**THREE-SIXTEEN**

**QUAD-CITIES NUCLEAR STATION  
MISSISSIPPI RIVER**

A DEMONSTRATION TO THE UNITED  
STATES ENVIRONMENTAL PROTECTION AGENCY BY THE  
COMMONWEALTH EDISON COMPANY UNDER SECTIONS  
316a and b OF THE FEDERAL WATER POLLUTION  
CONTROL ACT FOR THE QUAD-CITIES NUCLEAR  
STATION AT CORDOVA, ILLINOIS ON THE  
MISSISSIPPI RIVER

## Errata

Figure 37. Rotifers as a percent of total zooplankton compared above and below Quad-Cities Station, January 1973 through July 1974.

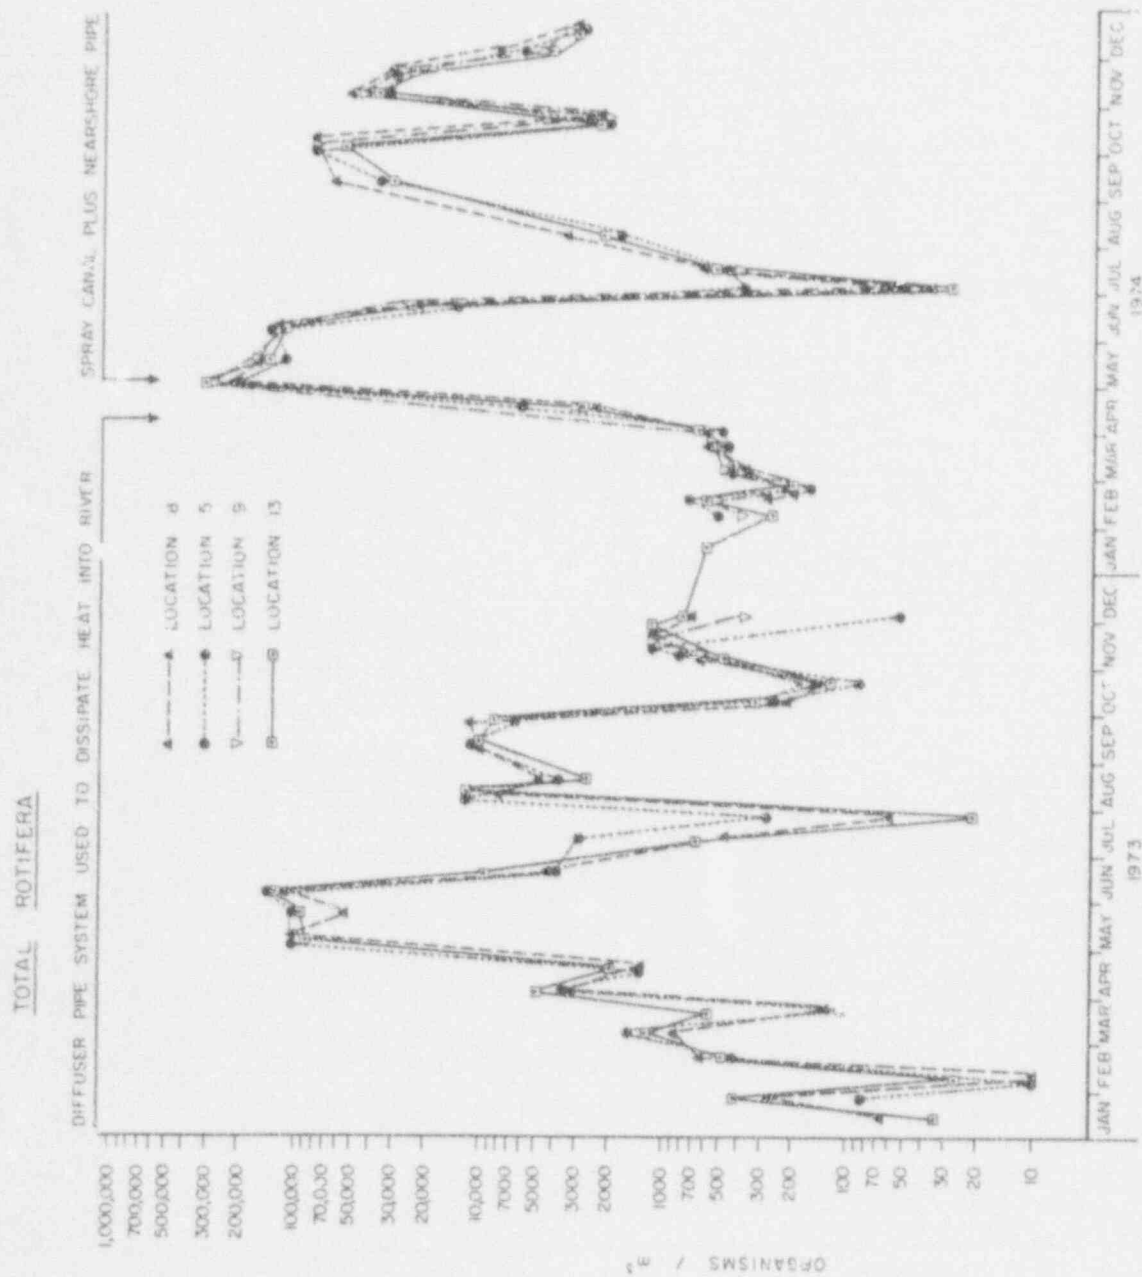
<u>PAGE</u>	<u>LINE</u>	<u>CHANGE</u>
150, 151, 152	Figures 37, 38, 39	Additional data is presented on the three major components of the zooplankton. However, the three curves that follow, (Figures 9.4, 9.5 and 9.6) taken from the latest semi-annual report are shown as numbers of organisms, rather than as percent of total zooplankton as was done originally for the 316a demonstration.
155	3	Eliminate quotation marks around the t
155	27	Change by to - bay
156	Figure 40	Original 316a graph is updated by page 345 (Figure 8.8) from the latest semi-annual report which follows this section but compares only upstream vs downstream. The original 316a Figure included a discharge bay station which was not a part of the river.
158	Figure 41	Original 316a graph is updated by page 344 (Figure 8.7) from the latest semi-annual report which follows this section but shows only the upstream/downstream comparisons. Additional periphyton data from the semi-annual report is also shown in forms not given in the original 316a demonstration: page 342, Figure 8.5 (periphyton biomass); and page 343, Figure 8.6 (periphyton biovolume).

Figure 9.4. Density of total Copepoda in the vicinity of the Quad-Cities Station, 1971-1974.

Figure 9.5: Density of total Cladocera in the vicinity of the Quad-Cities Station, 1971-1974.

Figure 9.6. Density of total Rotifera in the vicinity of the Quad-Cities Station, 1973-1974.

Figure 45. Mean monthly counts of Ephemeridae and Tubificidae in bottom samples compared above and below Quad-Cities Station and including mean monthly river flow rates, January 1971 through July 1974.

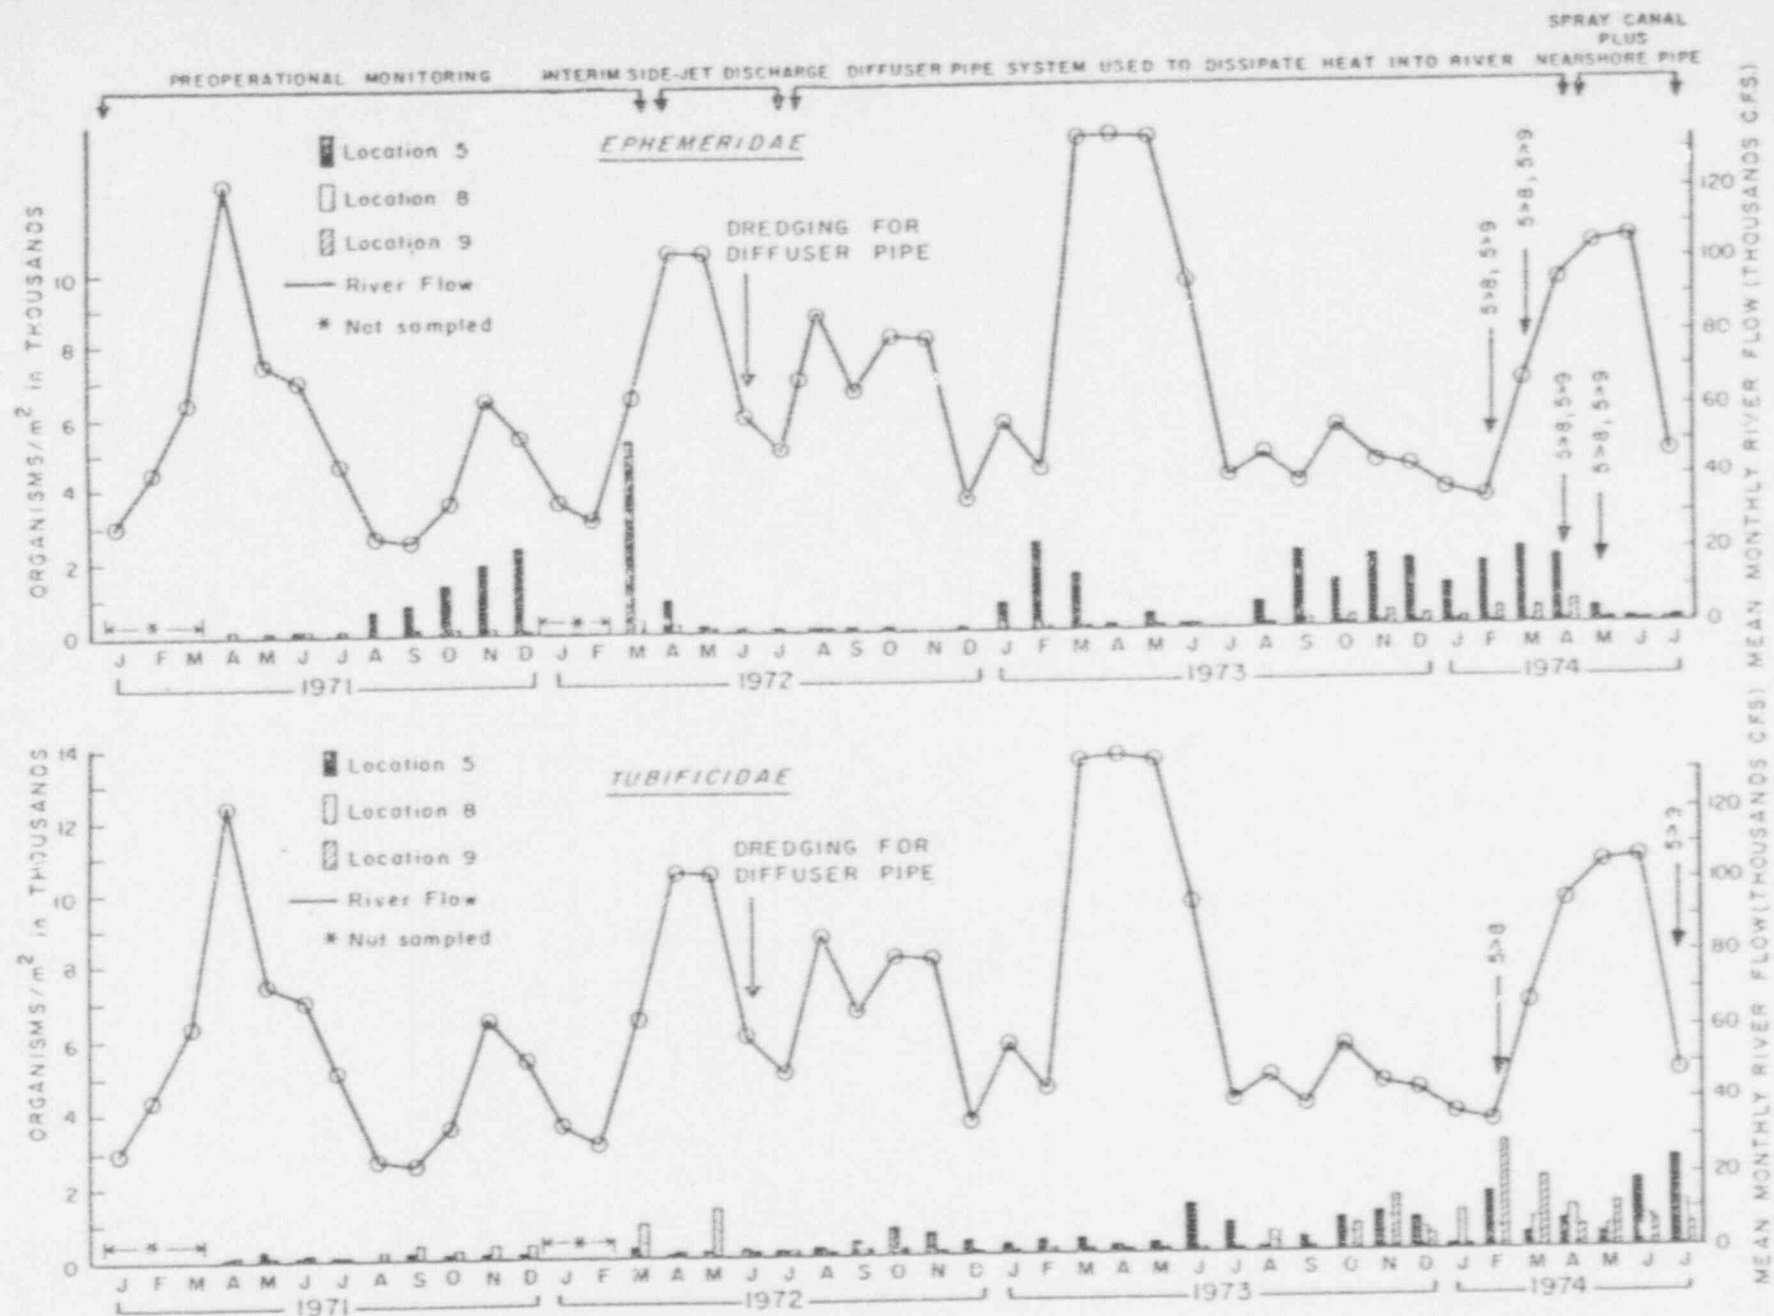
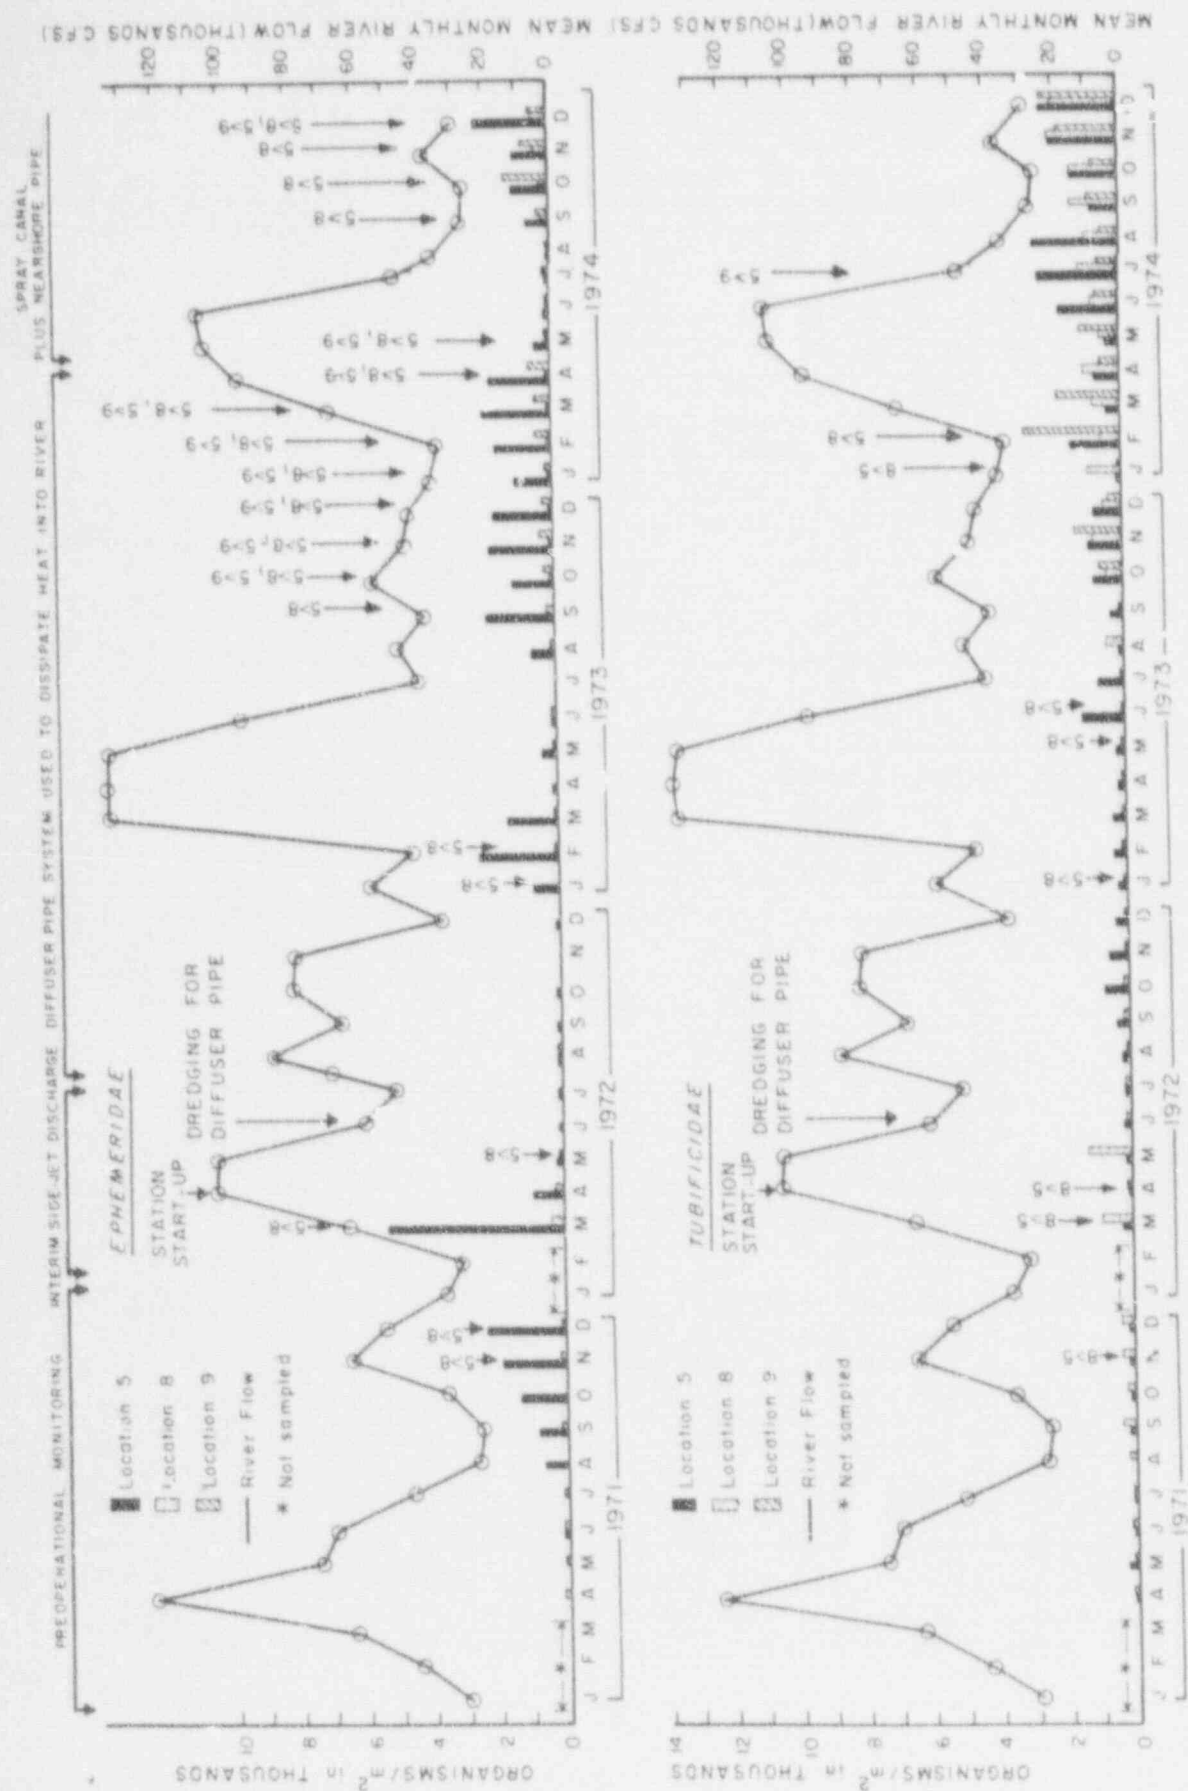
163	Figure 45	Original 316a graphs are updated by page 429 (Figure 10.4) from the latest semi-annual report which follows this section.
164	Figure 46	Original 316a graphs are updated by page 430 (Figure 10.5) from the latest semi-annual report which follows this section.
165	Figure 47	Original 316a graph is updated by page 428 (Figure 10.3) from the latest semi-annual report which follows this section.
173	Last	Eliminate the word - Certain
176	First	Capitalize the first word - Other
176	11	Eliminate - It is likely that Capitalize - Under

Figure 10.4. Density in numbers per square meter of Ephemeridae and Tubificidae collected near Quad-Cities Station, during 1971, 1972, 1973 and 1974.
